# The Sizewell C Project

SZC Co.'s Response to the Secretary of State's  
Request for Further Information dated 18 March  
2022: Appendix 3 - The Drainage Strategy  
Part 9 of 12

## APPENDIX F: DRAINAGE NETWORK LAYOUT WITH HYDRAULIC MODEL LABELS

## APPENDIX G: RECORD OF SCC COMMENTS AND SZC ACTIONS

**Drawing Title**  
 PRELIMINARY DESIGN  
 DRAINAGE HIGHWAYS NETWORK LAYOUT  
 SHEET 01

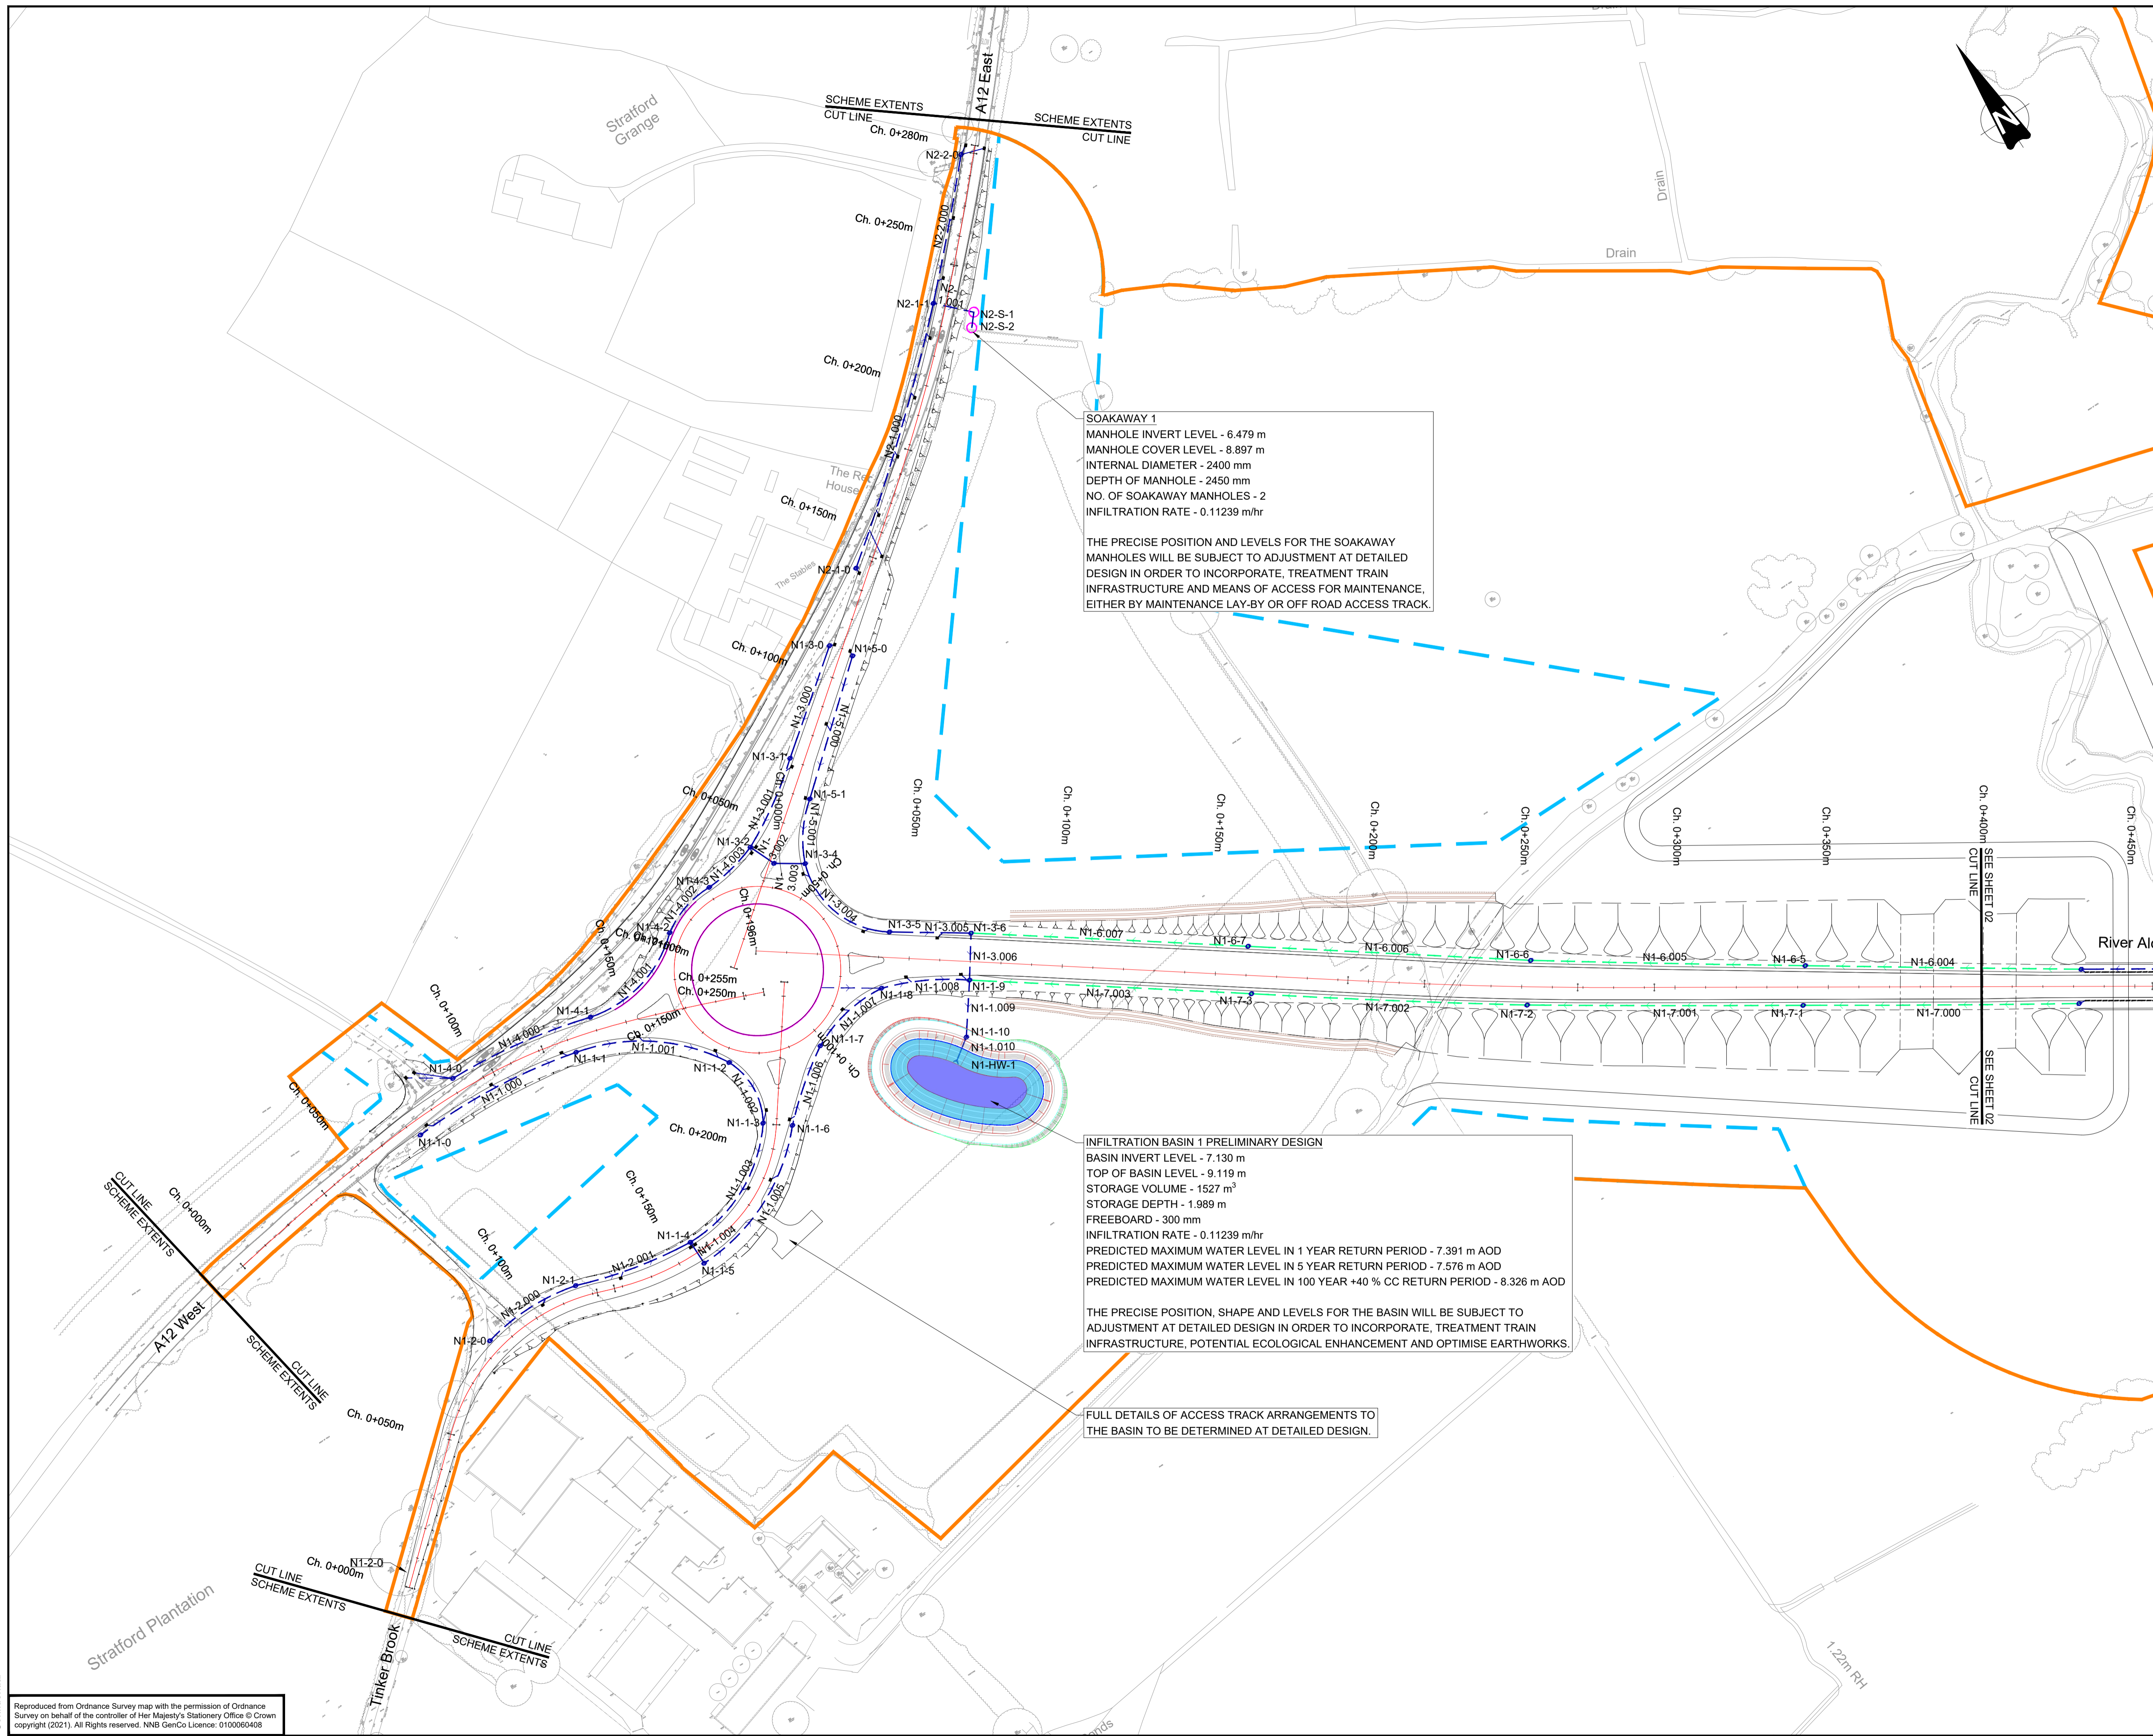
<p>Appendix A – It's not possible to use the plans that contain the locations of test results without context of the proposed scheme overlaid</p>	<p>Plan Added</p>
<p>Network 1 Infiltration rate used of 60.12mm/hr. This conflicts with Plate 10 but uses the right infiltration rate as far as SCC are concerned. Basin levels and modelled flood levels are different to that contained in Plate 10. Infiltration basin DS/PN is N1-1.010 with a weir overflow of 8.622m. Given this is an infiltration basin, I wouldn't expect to see any flow through this pipe but during 1:100+40% it is discharging at 12l/s. This is not in accordance with the proposed drainage strategy and does not represent the required attenuation volumes. In addition to the above, despite the offsite discharge, there is a cumulative flood volume of 96.661m<sup>3</sup>. This is a significant volume and I don't expect @Steve Merry would be content with this being retained on the road. Given the location next to the River Alde, it's likely this water would find its way to the river, thus increasing offsite flood risk, which is not something SCC can support.</p>	<p>See final comment. All Network Models will be updated at detailed design</p>

**Plate 5: Combined Railway and Road Infiltration Basin to the East of Abbey Road**

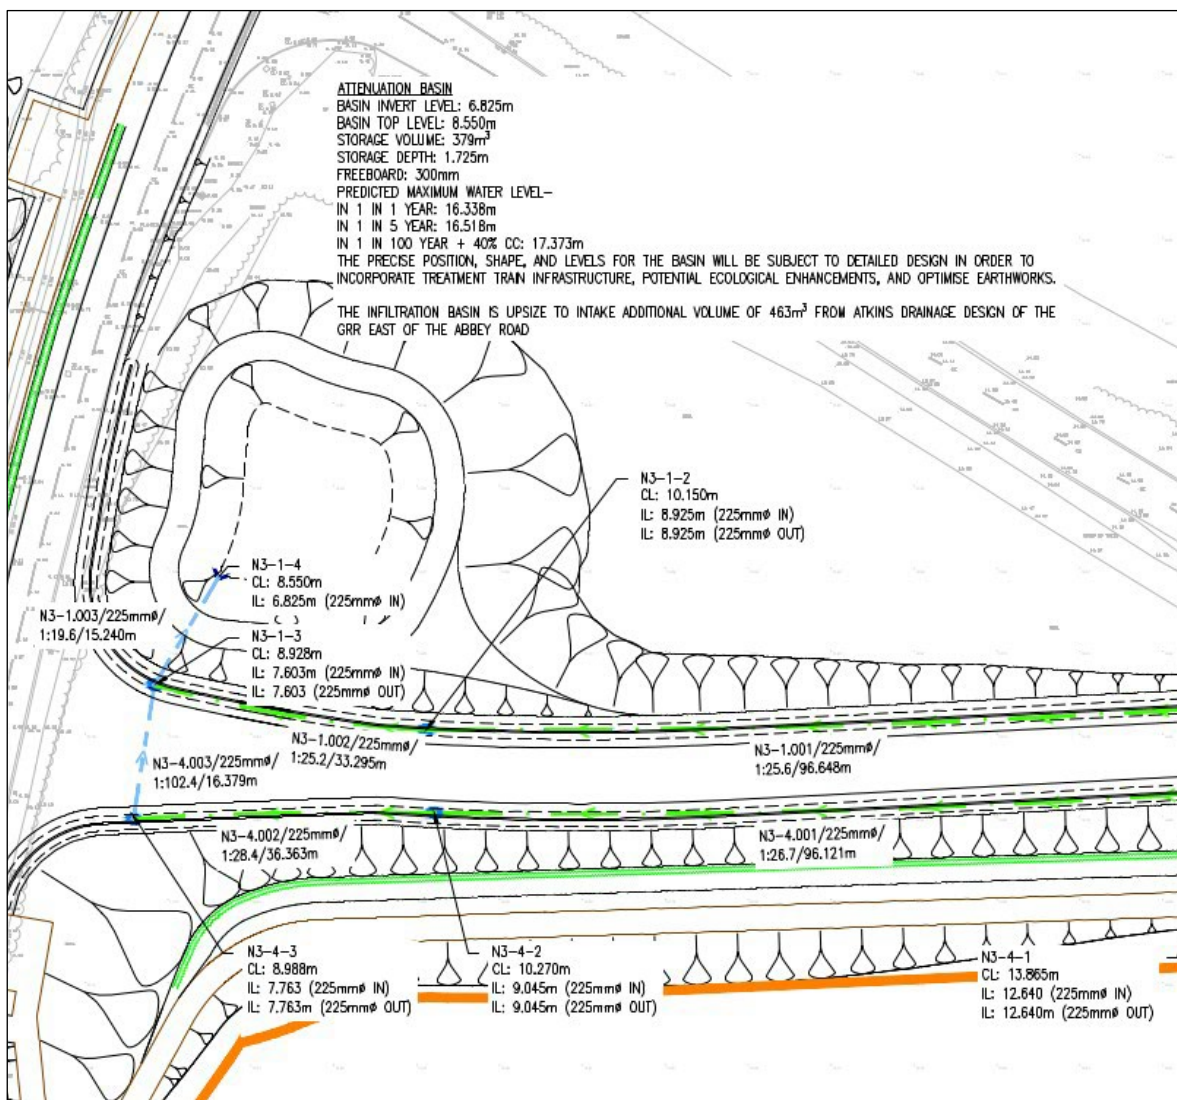
The calcs in Appendix F show a volume of 463m<sup>3</sup> storage provided. This accords with AD6 Technical Note, but 8.1.26 of this document states that an 'additional 463m<sup>3</sup>' is required. So, should it be 463m<sup>3</sup> in addition to the volumes already required, in which case you need more than the 463m<sup>3</sup> modelled? Table 4 of AD6 Technical Note only notes a 'storage volume top of bank' of 383m<sup>3</sup>.

The information contained in AD6 Technical Note and GRR Technical Note in relation to the basin East of Abbey Road should be the same as it is serving both areas, but there's no consistency and I can't say with any certainty what the cumulative attenuation volume requirements are, let alone confirm that sufficient attenuation is provided. The plans provided in both documents aren't consistent either.

The text in AD6 and GRR is modified for clarity to demonstrate that information is aligned
